TRANS/WP.15/AC.2/2002/1/Add.7
8 November 2001

Joint Meeting of Experts on the Regulations
annexed to the European Agreement concerning
the International Carriage of Dangerous Goods
by Inland Waterways (ADN)*
(Fifth session, 21-25 January 2002)

RESTRUCTURING OF THE REGULATIONS ANNEXED TO ADN

Part 8: Provisions for vehicle crews, equipment, operation and documentation

8.6.4.1 DEVICE FOR THE DISCHARGE OF RESIDUAL QUANTITIES

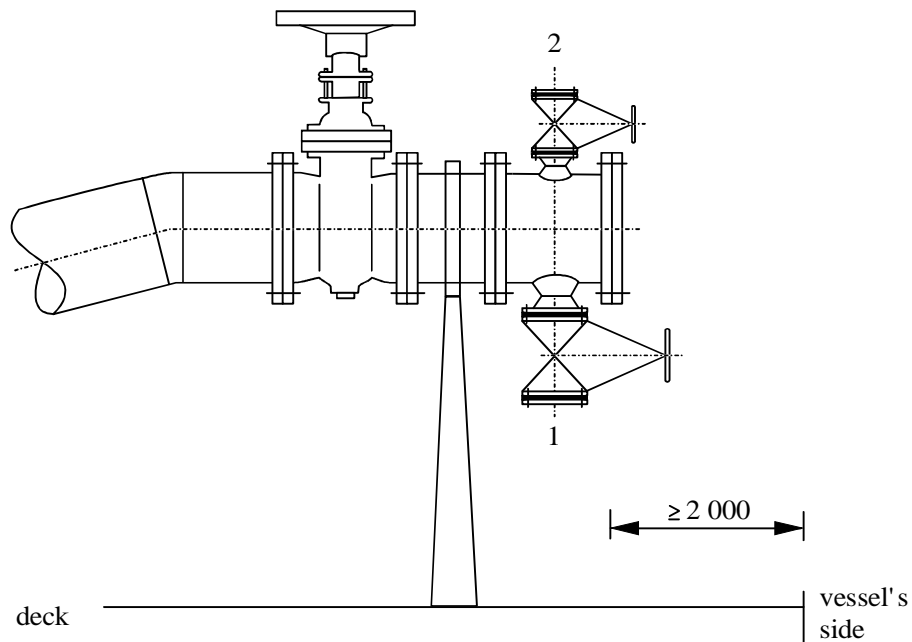
1. Connection for the discharge of residual quantities
~~Connection conforming to CEFIC~~
2. Connection of the shore installation intended for blowing residual quantities to the short installation by means of a gas
~~Connection conforming to CEFIC~~
